Interactive comment on “Full field assessment of wind turbine near wake deviation in relation to yaw misalignment” by Juan-José Trujillo et al.

Introduction

Fig. 1. Approximated theoretical expectation of the effect of wind turbine misalignment on wake skewness with respect to induction (a) or thrust coefficient (Ct)

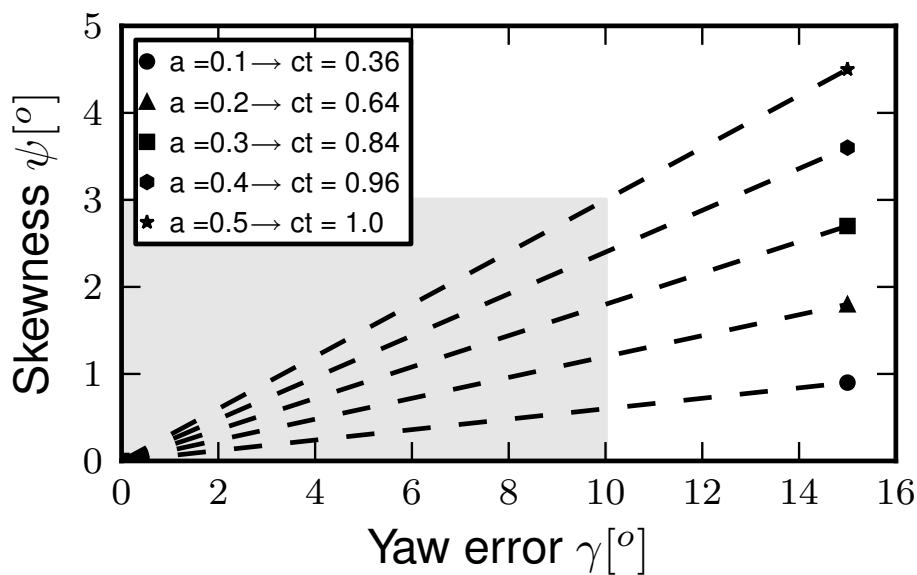
§4.1. Knowing the thrust coefficient, it is possible to assess the expected velocity deficit and so, the expected axial induction factor. One can then compare this velocity deficit with the one obtained in the present data base. One can also assess the expected

skew angle of the wake, which depends on the axial induction factor and the yaw angle. According to a rapid calculation, the skew angle of the wake should be 1.16 times higher than the yaw angle. However, this skew angle is not taken into account in the present study: why?

You are right that there is an expectation of a skew angle. As we mention in the discussion it is not possible to resolve the very small skew angles which are in consideration with the measurement setup in this research. As you point out we do not explain in detail the background of this to be concise in the paper. A solution could be to add an explanation into a short annex to the paper.

From theoretical considerations the wake deviation (χ_o) can be approximated as $\chi_o \simeq (0.6a + 1) \cdot \gamma$ (see vortex model in Burton et al. 2011) what derives into a skewness equal to $\psi \simeq 0.6a\gamma$. This behaviour is depicted in Fig. 1, where an approximate value of thrust coefficient C_T is given for the case of no misalignment. This is done taking into account that based on the vortex model the thrust coefficient is rather unaffected by yaw errors in the order of magnitude shown in Fig. 1.

The shaded area depicts approximately the yaw misalignment values which are covered during this experiment. As a consequence the highest values of skewness that could be expected are below $\psi \simeq 3^\circ$. However, this value lies already in the order of the typical uncertainty assumed for nacelle wind vanes. Therefore we conclude that the wake skewness can not be resolved from pure yaw misalignment measurement by the standard wind vane at the nacelle in this experiment.

In regards to the lidar measurements it is not possible to assess an uncertainty, as explained in the paper, since the lidar mounting error in azimuth cannot be exactly determined. Consequently, the orientation errors cannot be diminished to isolate the systematic effect of skewness. One could be tempted to make some interpretation of the values of $\Delta\gamma$ in Tables 2 and 3 in the paper, however this would be just specula-

tion. In conclusion, the accuracy of the experiment is not enough to resolve the wake skewness for each misalignment angle.
